Incorrect Speaker Mapping, Alternator Whine – Premium Sound System – DIN Plug Damage

MODEL 1995 MY
Sedan Range
VIN 720001-ON

ILLUSTRATION 1

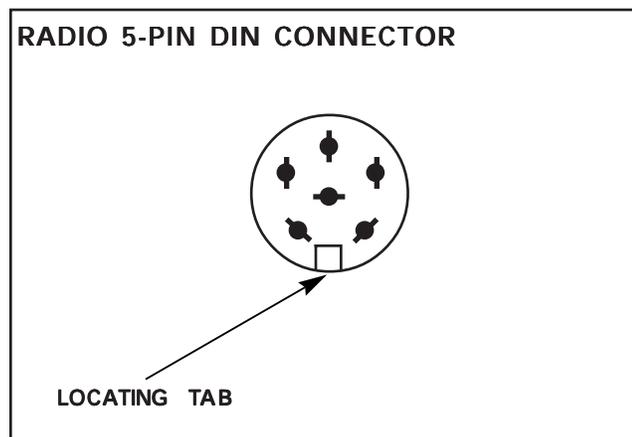
When reconnecting the grey 5-pin DIN plug at the rear of the premium sound system radio, it is possible to force the connectors together improperly. The connector can be accidentally assembled 180 degrees out of alignment due to the thin diameter of the male pins.

If this occurs, the shield wire is left open, allowing alternator whine to be heard through the speakers. In addition, the outputs leading to the Harmon-Kardon amplifier are reversed causing reversed operation of the fader and balance controls.

The male pins may also be damaged beyond repair.

When reconnecting the 5-pin DIN connector, check that the locating tab is positioned at the bottom, Illustration 1.
